Clonburris SDZ- Adamstown Extension
Landscape Response to RFI

This report forms part of a submission to South Dublin County Council (SDCC), in response to their request for additional information for the proposed residential development on lands at Clonburris, Adamstown, Co. Dublin, part of the Clonburris Strategic Development Zone (SDZ). This report addresses the landscape related items raised in SDCC's further information request.

Planning Reference: SDZ23A/0004

Typical section through southern boundary

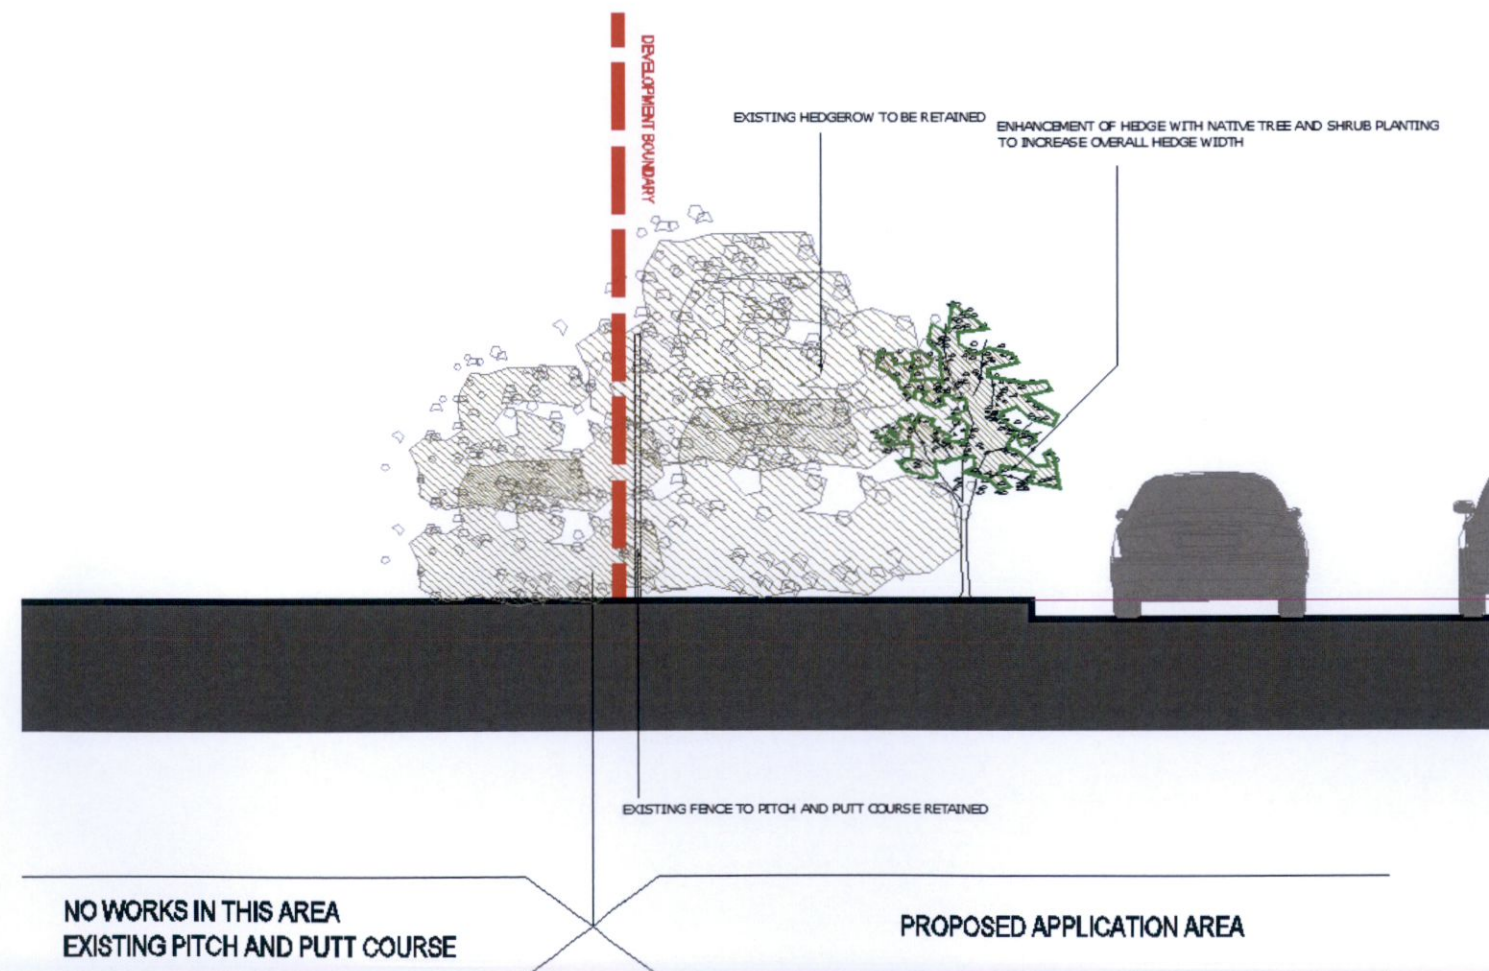
Much of the hedgerow removal is considered unavoidable in order to deliver this development however, removal of Hedgerow H3 along with trees along the southern boundary is considered excessive and damaging to the local green infrastructure. The applicant is requested to provide revised plans to include the retention /enhancement of this hedgerow.

The design has now been revised to completely retain the southern hedgerow. The original submitted design included fencing to this hedgerow to provide a defined boundary to the local street and ball netting to the adjoining pitch and putt, but these have now been omitted to mitigate the impact on the existing hedge. There is existing security fencing to the pitch and putt boundary and it is considered that the hedgerow provides a sufficient screen between the course and the proposed development. It is now proposed to provide a wider offset between the hedgerow and the proposed road by moving the alignment of the proposed southern local street to the north, providing an ample buffer zone to avoid root disturbance. Enhancement of the hedgerow is proposed with additional native shrub and tree planting.

It is now proposed to retain and enhance the southern boundary hedgerow. The east-west road along the southern site boundary is to be moved to the north, meaning that the hedgerow can be retained intact. It is proposed to enhance this feature by including additional infill planting (refer to the drawings prepared by Brady Shipman Martin in response to the RFI for full details). The evaluation of the impact remains probable, permanent and significant at the local scale. However, the result of this change (the retention and enhancement of the southern hedgerow) is to marginally reduce the scale of the overall impact on biodiversity of the proposed development.

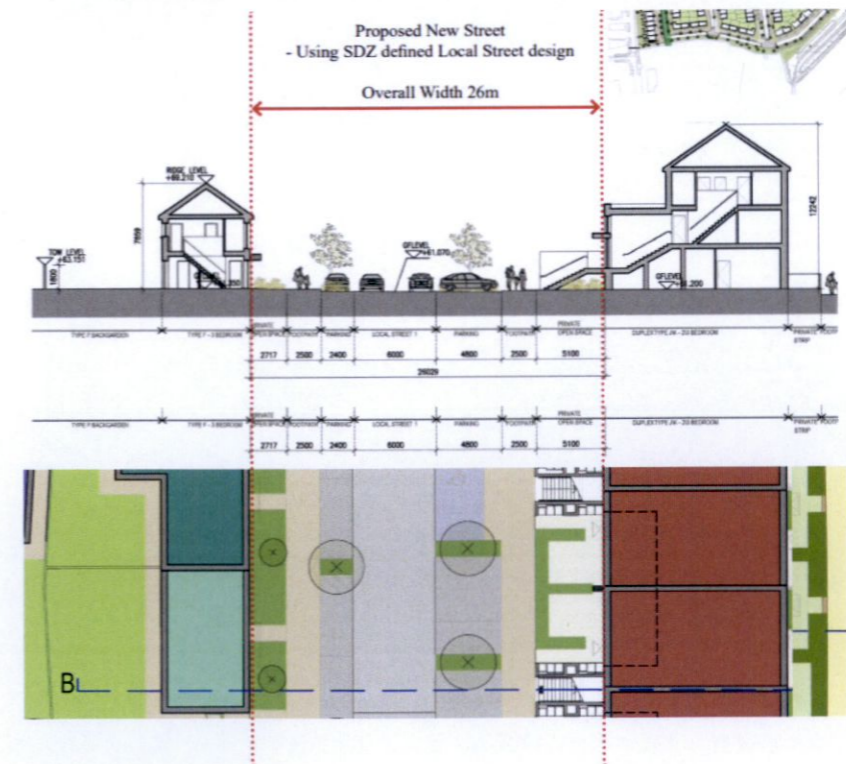
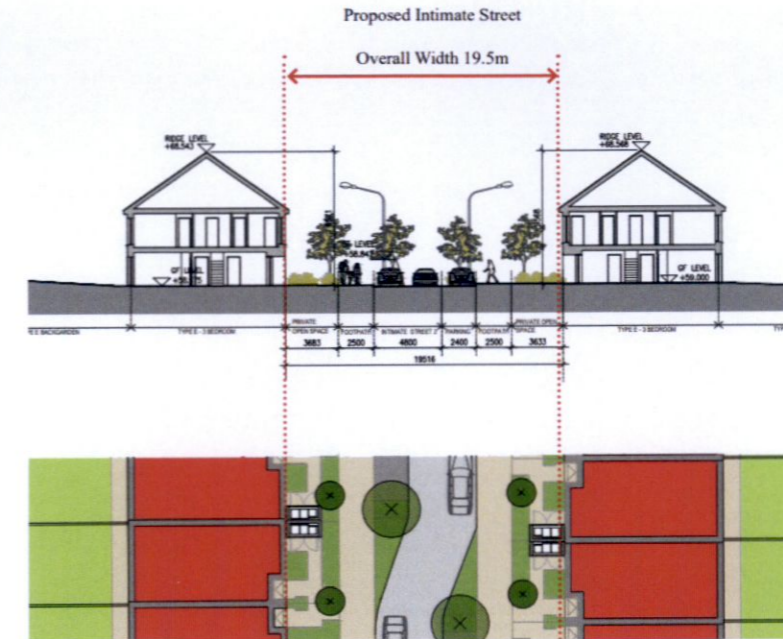
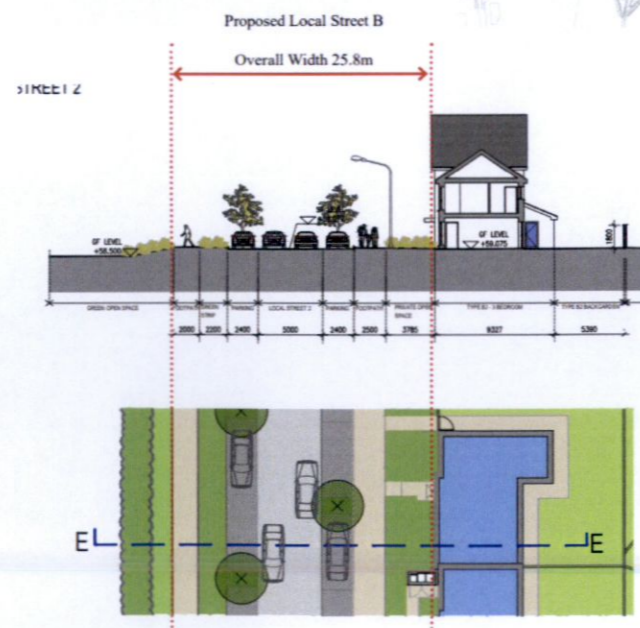
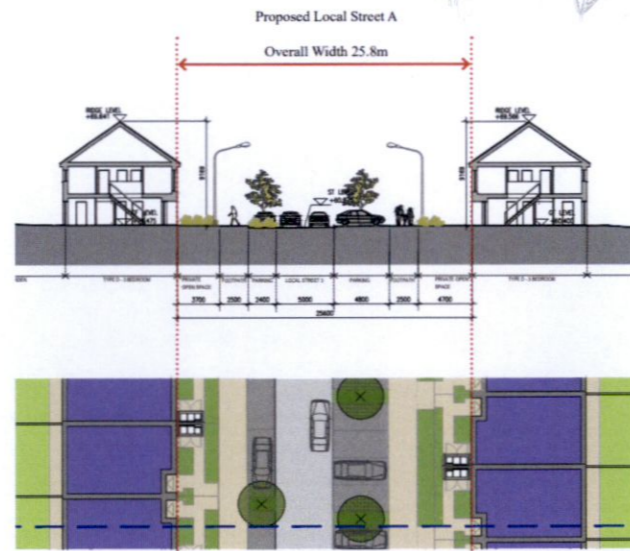
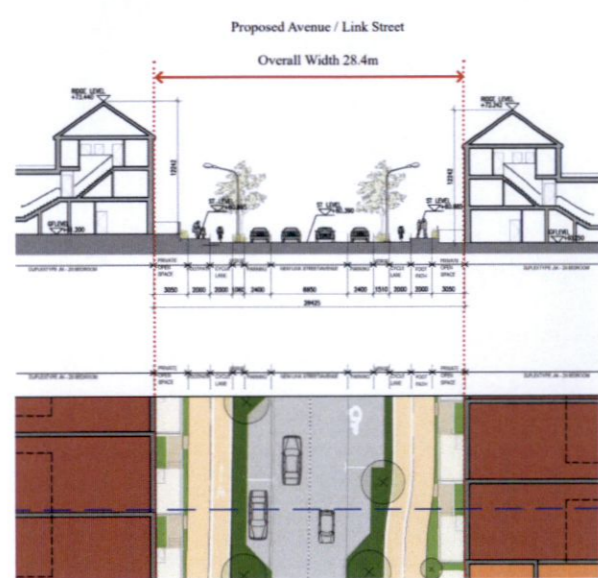
The applicant is requested to revise plans to include additional street trees on local street 2,3, 9, 7. Currently only one side of street is planted.

A revised street typology has been developed which includes street planting to both sides of the local streets. Indicative street typology drawings showing tree planting to both sides of proposed streets are provided below. Further information on street typologies is provided in the Architectural response, Architectural Design Report. The positions and specifications of street trees are provided on the Landscape Masterplan and Tree Strategy Plan.

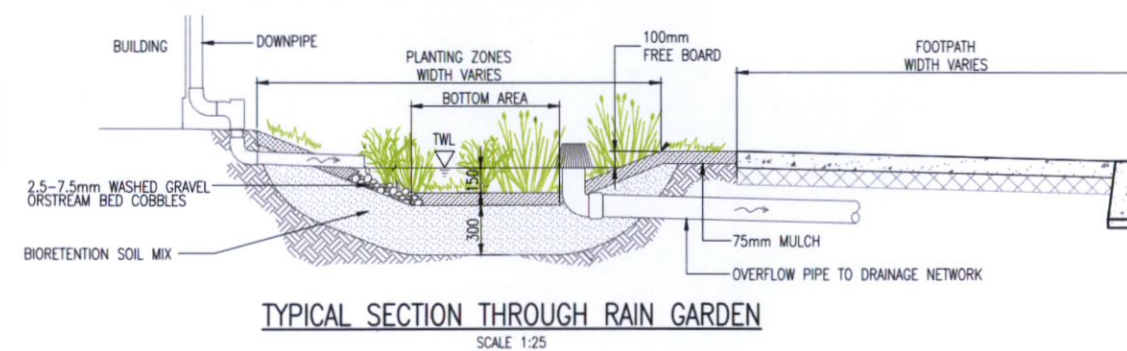
The applicant is requested to provide revised plans to demonstrate the use of SUDS for water treatment, amenity and biodiversity. Please refer to SDCC SUDs Guide. Swale details to be revised to include min 1 meter width at base of swale and consider planting to increase amenity and biodiversity value.

Bio-swales will be provided to parkland boundaries. Following consultation with Laurence Colleran at SDCC, the swale will incorporate check-dams to help retain water and increase the variety of inundation and resulting habitats, as well as enhancing opportunities for play. BSM notes the councils request for the omission of decorative planning, in lieu of wild flowers. The base width will be increased to 1m.

In addition, rainwater infiltration will be provided across the residential areas of the site through Stockholm-style tree pits for all trees within paved areas, as well as rain gardens within residential curtilages that will provide biodiverse and aesthetic features. Both tree pits and raingardens will be planted with variety of pollinator friendly groundcover and taller perennial herbaceous and grass species. Typical SUDS details are provided as part of the Civil Engineering Response from Waterman Moylan. For details of how SUDS will provide water treatment services refer to Section 2.1 of Response to Civil Engineering Items.

Vegetation cover to swales will be native Irish wildflowers.

Swales will utilise check-dams composed of natural materials where feasible

Plan showing indicative alignment of potential future cycle route (to be developed by others)

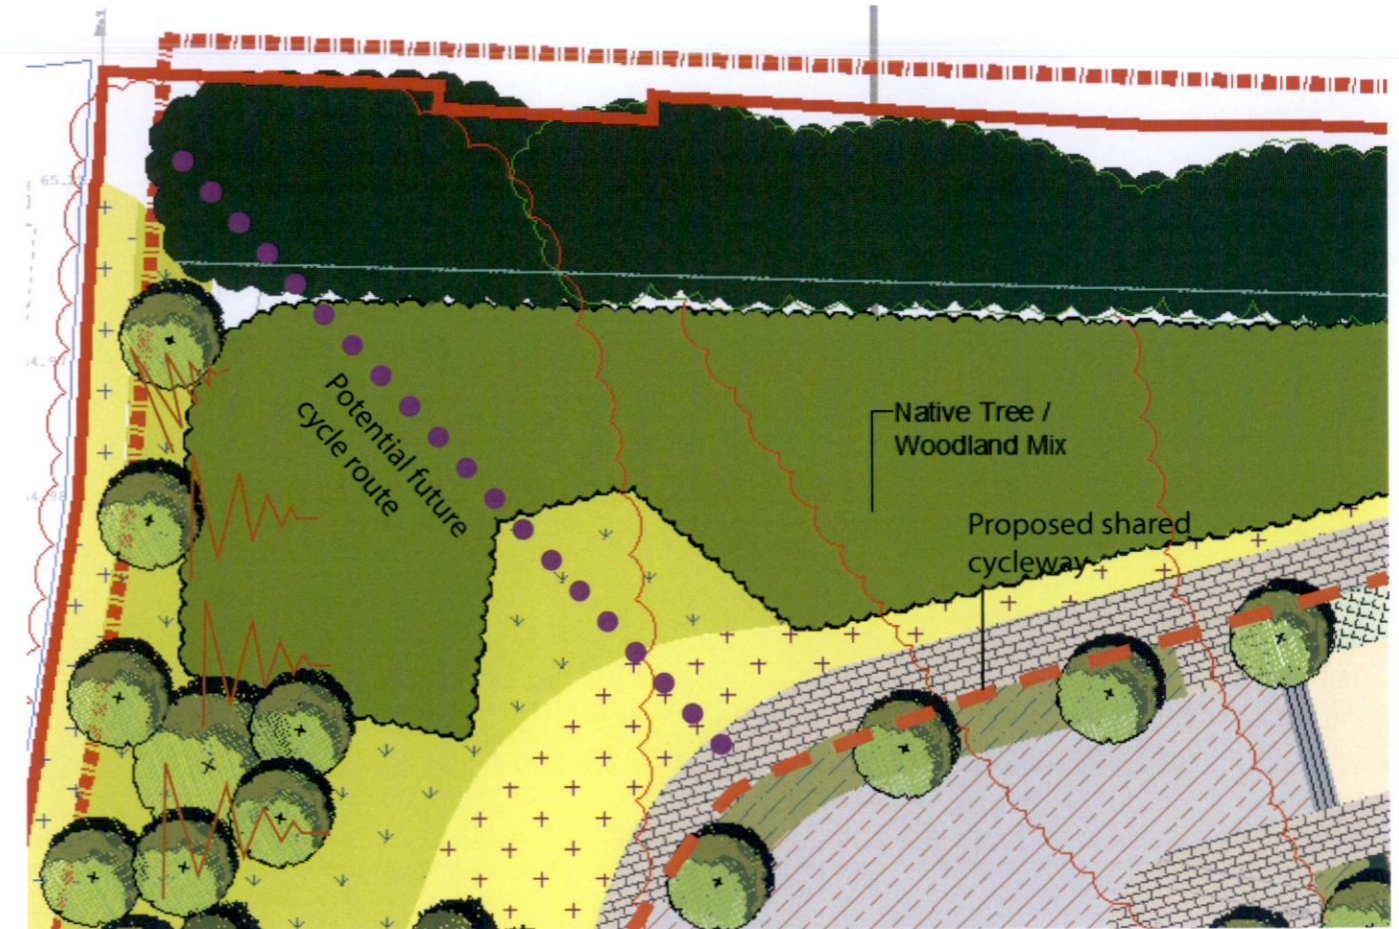
Applicant to provide details of how the Greenway that follows the western rail corridor will be continued under the road/rail bridge to the NW corner of the subject site.

It is not proposed to include a cycleway connection under the R120 railway overbridge as part of this application. Currently there is no development site to the west which to connect to and therefore the route would terminate under the bridge. It is considered that provision of access to the under bridge area at this time would encourage anti-social behavior, create a safety risk and potentially endanger safe operation of the railway.

However, the landscape design will accommodate a future spur extension by SDCC or others: the proposed topography will allow for a gently graded cycleway; a recess in the woodland planting will be included to minimise the amount of future felling / vegetation clearance required while still providing an adequate screen to the northern boundary. In addition, there is a gap between the bridge abutment and the existing security fencing which would allow a cycleway to be provided in future if necessary.
